Product Change Notice (PCN)

PCN Number: PCN-0455041R-01

Product(s) Affected: SJ1-355XNG series. SJ1-3553NG, SJ1-3554NG, SJ1-3555NG & SJ1-3555NG-BE

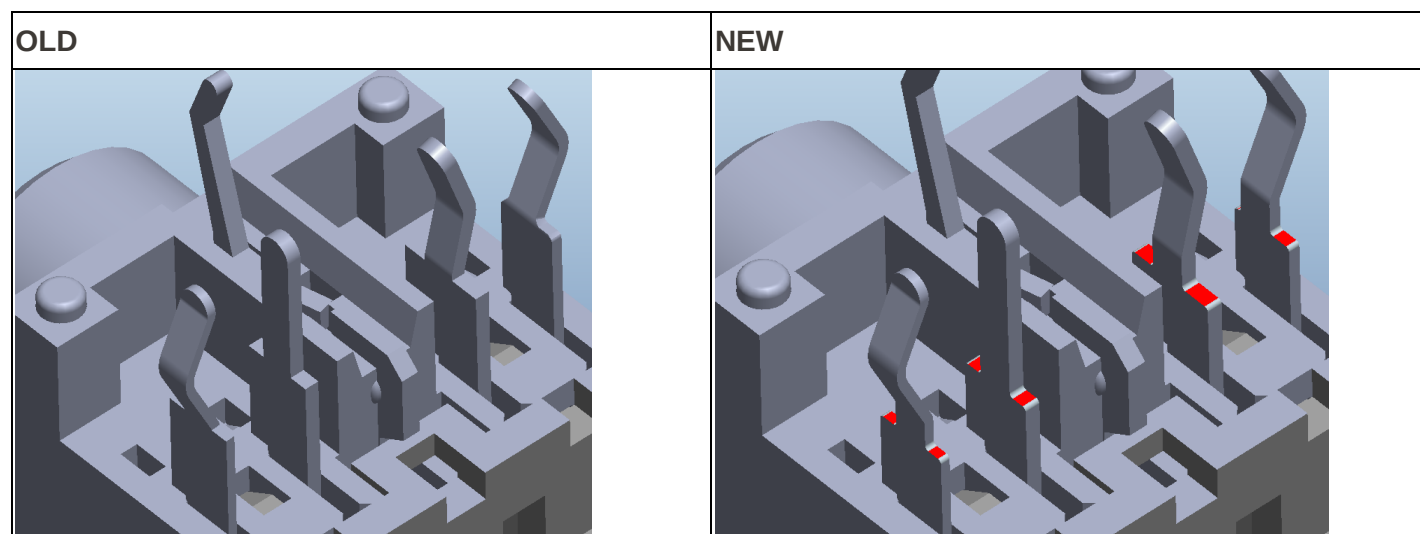
Description of Change: *Reduce the body of the PCB pins, increasing the insertion depth of the pins.*
